Service Bulletin

PRELIMINARY INFORMATION

Subject: Difficult to Engage Clamp(s) When Installing Soft Roll-up Tonneau Cover

Models: 2014 Chevrolet Silverado 1500
2015 Chevrolet Silverado
2014 GMC Sierra 1500
2015 GMC Sierra
Excluding 8 Foot - Long Box Vehicles

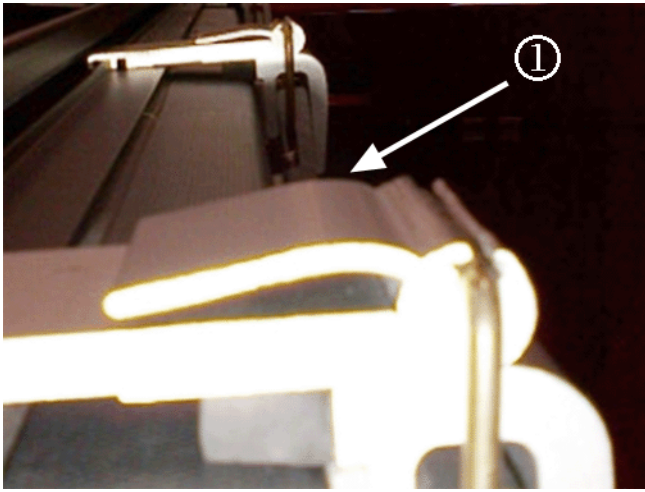
During installation of the soft tonneau cover, technicians/customers may find it difficult to engage the clamp(s).

The cause of this condition may be the clamp bulb seal (1) not compressing enough to allow the bail (2) on the clamp to rotate to the lock position.

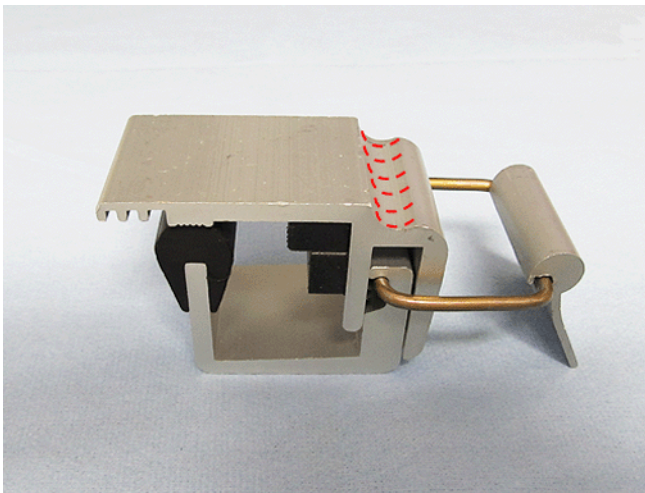
Important: Using excessive force to rotate the bail to lock position could damage the bail. If the bail of the clamp is bent (1) as shown in the graphic above, the clamp assembly will need to be replaced. The proper service part can be found in the Electronic Parts Catalog (EPC).
